Q1.11.6.6 Bedford Borough Council Applicant Sustainable development

Provide further detail and plans to support the comments in your RR regarding access to EWR stations and, space to accommodate other modes of travel on Barford Road overbridge, adjacent to the ECML and under the new road [RR-008a].

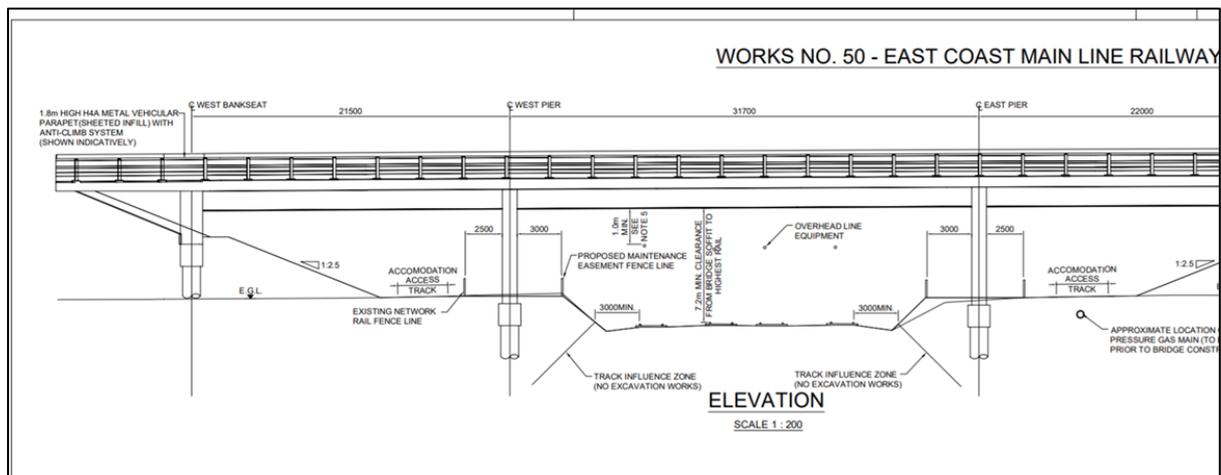
With development proposed both north and south of the new stations (whichever is chosen), the Council believes that provision should be made for formal sustainable transport routes under the new road where it crosses the East Coast Main Line. This would allow for pedestrians, cyclists and other vulnerable users to travel from the station to the new developments via a segregated, off-road route.

The cross section below shows strips labelled "accommodation access tracks" to the east and west of the ECML. This looks to be land that won't be retained in Highways England's ownership but could be used for foot / cycle routes under the new road, and agreement to retaining these access routes would make good sense.
